Field Report No.: 11															
	SP	&A Project No:	22.331							Report Date	4	Time: 9:30AM			
	(Project: Name & Location)	Juliet Lo 1854 CT- Gales Fe General	12 rry, (СТ 0	6335									
			Gold Sea	al Ro	ofin	g, LLC							_		
Weather							Site Conditions					Day of Week			
		Range: 70°					⊠ Clear			Dusty	□ Monday □ Thursday				
☐ Clear ☐ Rain ☐ Fog ⊠ Overcast ☐ Snow ☐ Co							☐ Muddy □ Other		L	Windy	5			⊠ Friday	
☑ Overcast □ Snow □ Cold □ Hot □ Other Type of Work Observed Being										🛛 🗆 Wednesday 🛛 Saturday					
4		Cite weath	1					a Bein 13			Feed	19		Onvinkler	
1		Site work 7				General Trades/Drywall		13		Specialties/ Food Service		19		Sprinkler	
2		Demolition	8			ows & Doors	14		Elevators		20	\boxtimes	Finish metal		
3		Concrete				Roofi	ng	15		Plumbing		21		Iron workers	
4		Masonry	10		Floor	ing	16		HVAC		22		Tester (Tri-state)		
5		Steel/Misc. Metal	11		Pool		17		Electrical		23		Audio Vis/Low Volt

FIELD REPORT

Roof A – Looking east

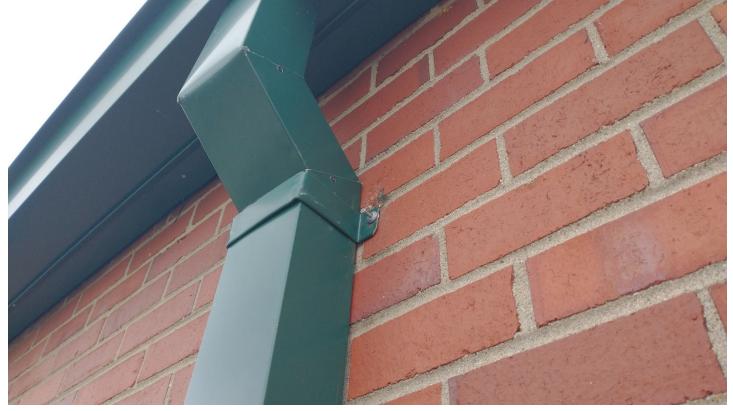
Roof A - Nail heads need to be covered with covered sheet
